Access Compliance Report

Public Rights-of-Way

(Curb Ramps)

Intersection ID: 10042563	Main Street: HIGHLAND_PARK_DR	Cross Street: N/A	Location: SE
ADA ID: 23819F1C9E85	Ramp Type: Perp	Initial Pass/Fail: Pass	Overall Compliance: No
Severity Score: 10			
Codes/Mitigation Info/Possible Solution		Field Measurements/Component Compliance

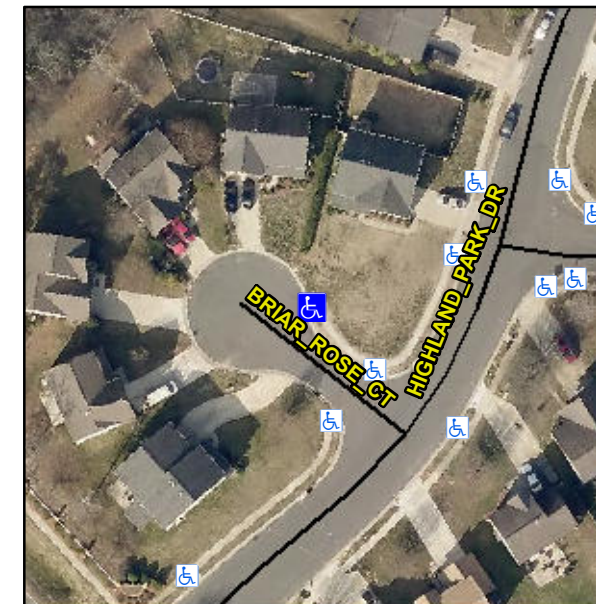
Not Found, R304.2.1, R305

Compliance	Description	Data	Compliance	Description	Data
N/A	Ramp Length (in)	47.0	Yes	Ramp Slope (%)	5.3
Yes	Ramp Width (in)	48.0	Yes	Ramp XSlope (%)	0.2
N/A	Flare Type LT	Sloped	N/A	Flare Type RT	N/A
N/A	Flare Slope LT (%)	5.4	N/A	Flare Slope RT (%)	3.4
N/A	Flare Traversable LT?	No	N/A	Flare Traversable RT?	No
No	Landing Length (in)	46.5	No	DWS Provided?	No
Yes	Landing Width (in)	48.0	N/A	DWS Contrast?	No
Yes	Landing Slope (%)	0.2	N/A	DWS Length (in)	N/A
Yes	Landing X Slope (%)	0.3	N/A	DWS Full Width?	No
N/A	Landing Curb? (Y/N)	No	N/A	DWS Offset (in)	N/A
N/A	Shared Landing?	No			
Yes	Gutter Ponding?	No	Yes	Gutter Slope (%)	0.9
Yes	Gutter Lip Ht (in)	0.0	Yes	Gutter X Slope (%)	0.9
N/A	Painted X Walk1?	No	N/A	Painted X Walk2?	N/A
	X Walk 1 Direction	To W		X Walk 2 Direction	N/A
N/A	X Walk 1 Width (in)	N/A	N/A	X Walk 2 Width (in)	N/A
	X Walk 1 Slope (%)	1.4		X Walk 2 Slope (%)	N/A
	X Walk 1 X Slope (%)	1.9		X Walk 2 X Slope (%)	N/A

Remove & Replace Entire Ramp.
